**SUBJECT:** R-Area Groundwater (NBN) Biennial Effectiveness Monitoring Report in Support of R-Area Operable Unit (U) January 2021 through December 2022 (SRNS-RP-2023-00758, Revision 1, June 2024) and Savannah River Site's Responses to the Regulatory Comments on the Revision 0 Document, SEMS Number: 95

1. R-Area Groundwater (NBN) Biennial Effectiveness Monitoring Report in Support of R-Area Operable Unit (U) January 2021 through December 2022 (SRNS-RP-2023-00758, Revision 1, June 2024) SEMS Number 95
2. SRS Response to the U.S. Environmental Protection Agency's Comments on the R-Area Groundwater (NBN) Biennial Effectiveness Monitoring Report in Support of R-Area Operable Unit (U) January 2021 through December 2022, SEMS Number: 95, SRNS-RP-2023-00758, Revision 0, August 2023
3. SRS Responses to the South Carolina Department of Health and Environmental Control's Comments on the R-Area Groundwater (NBN) Biennial Effectiveness Monitoring Report in Support of R-Area Operable Unit (U) January 2021 through December 2022, SEMS Number: 95, SRNS-RP-2023-00758, Revision 0, August 2023

Revised Figure E-2

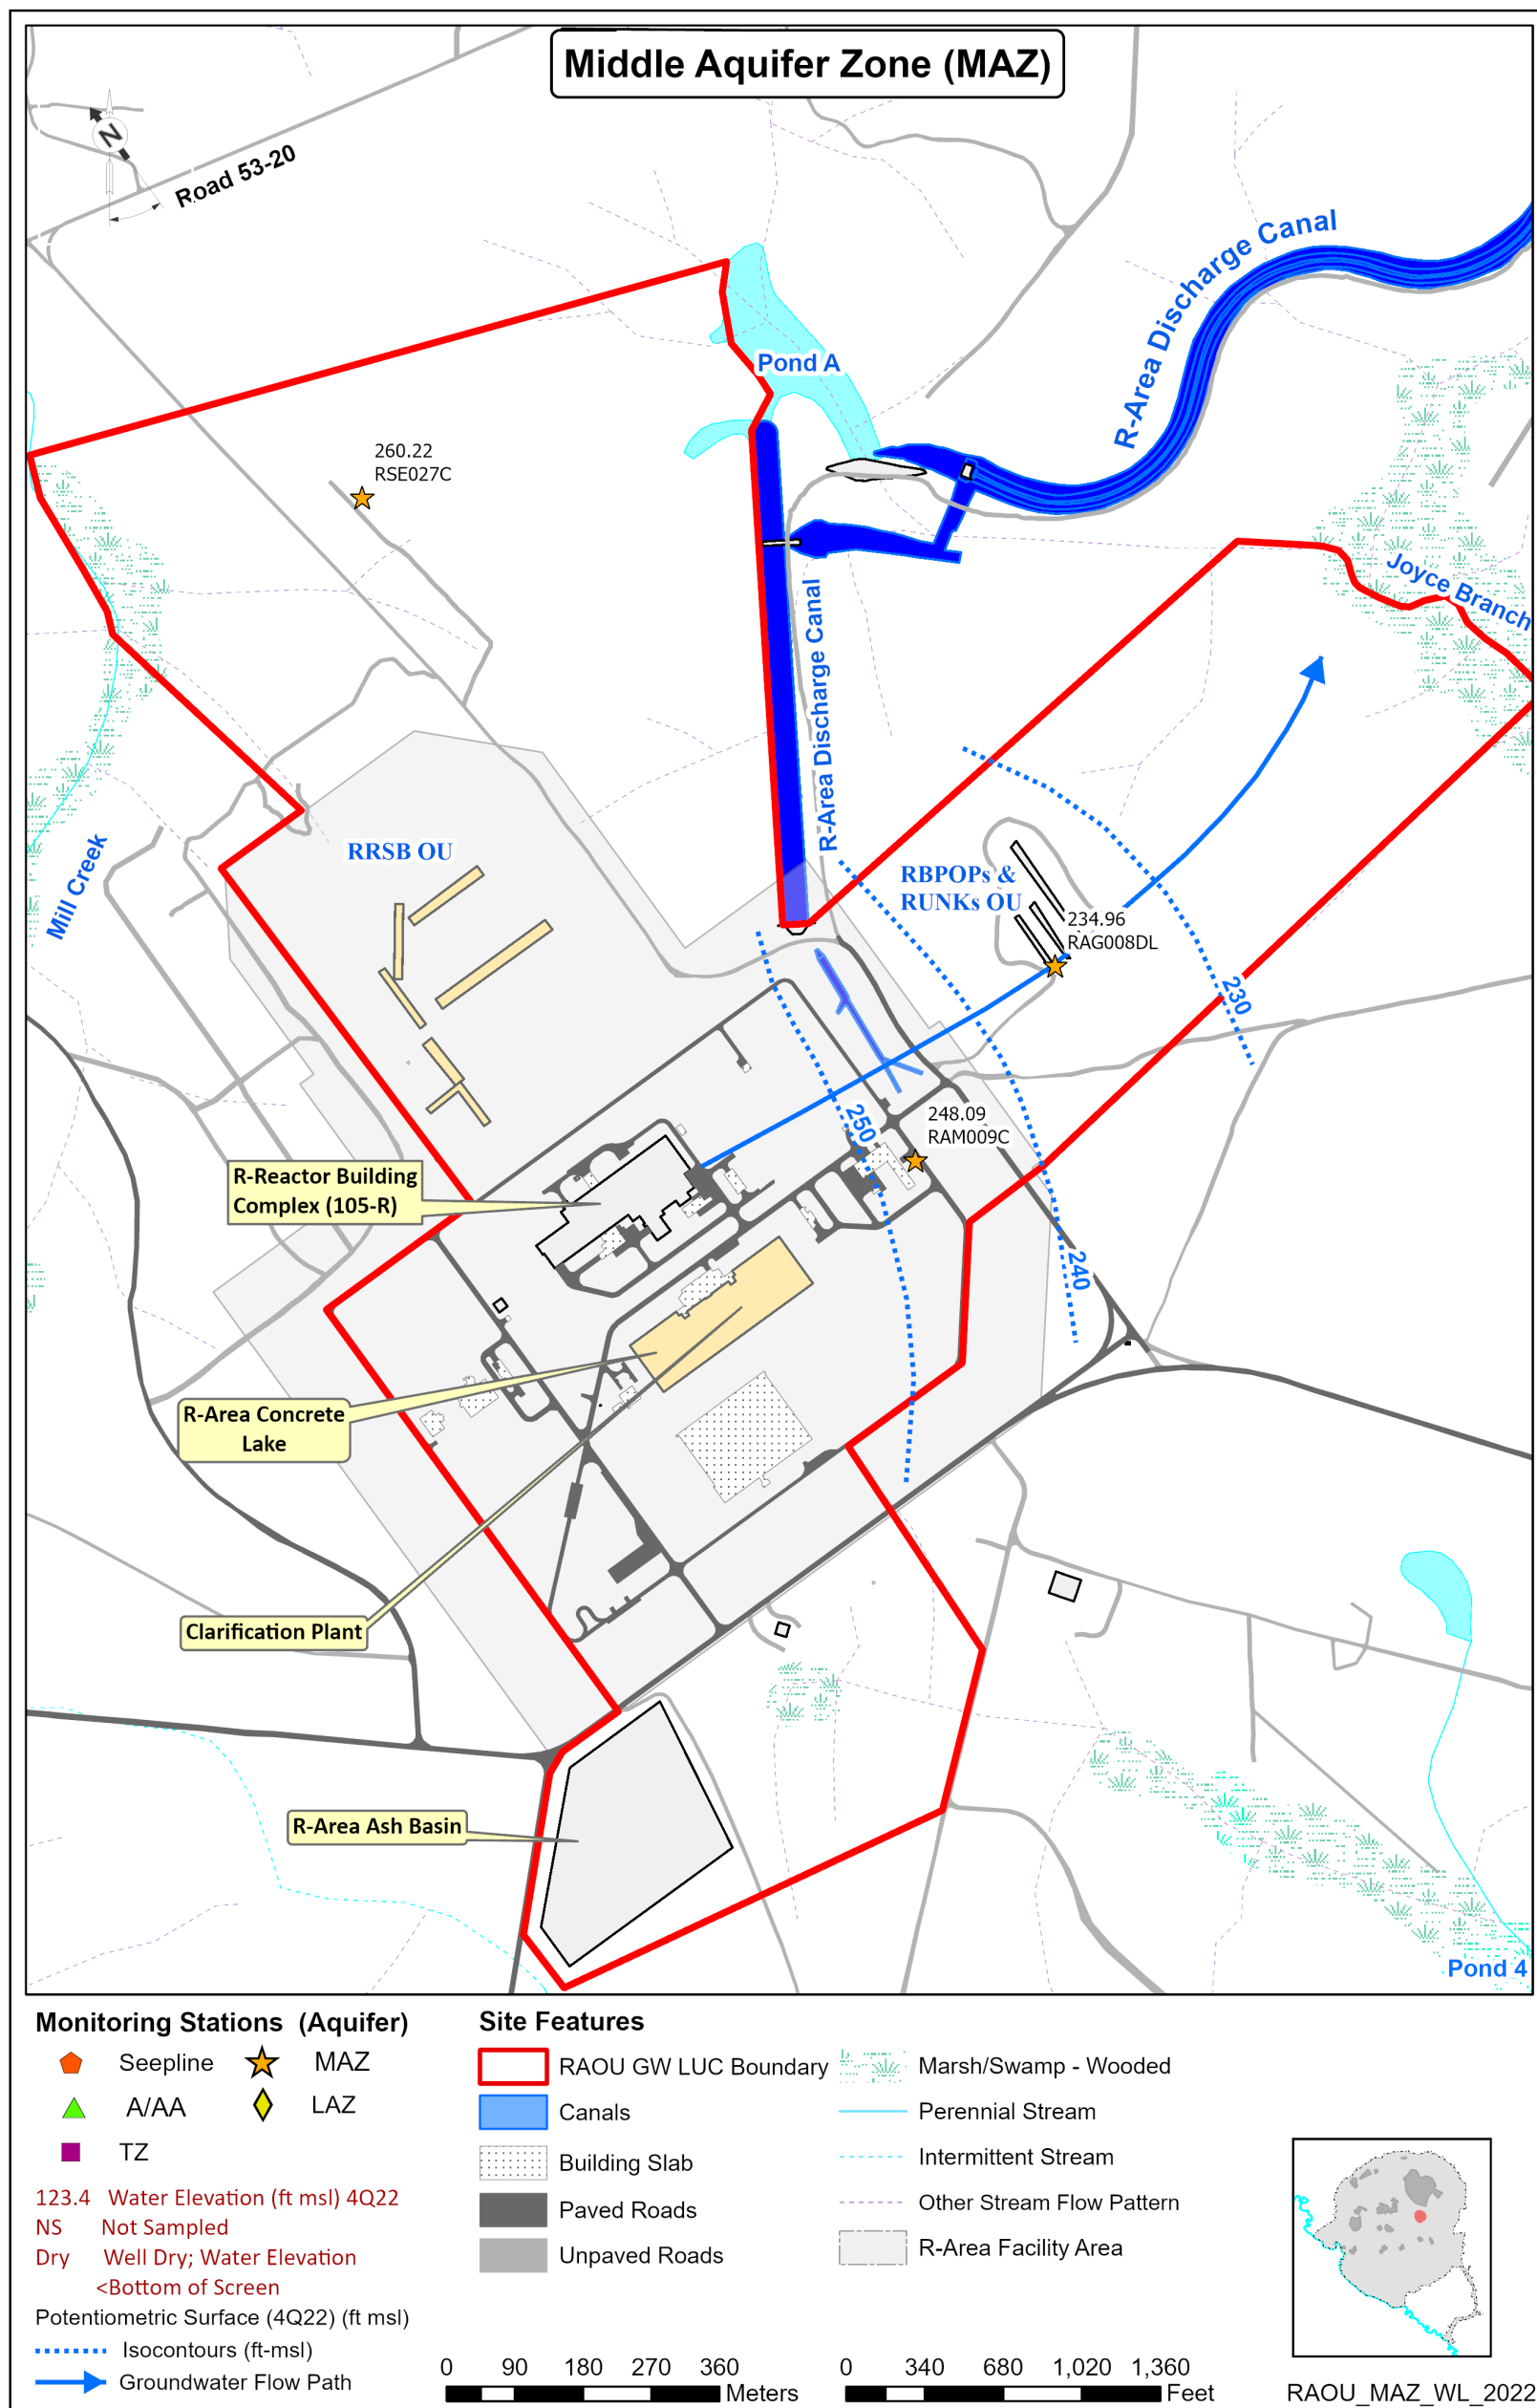
- d. Figure E-2, R-Area MAZ Well Water Elevations 2022, page E-5. Please see the following comments.
- i. MAZ wells are marked with purple stars which are not included in the legend. The legend indicates that MAZ wells are marked with orange stars.

- ii. The figure includes RAM009C and a well from the RAG008 cluster, but Table 1 does not identify any of these wells as MAZ wells.

**The purple stars have been replaced with orange stars.**

**Table 1 has been revised to label wells RAM009C and RAG008DL as MAZ wells.**
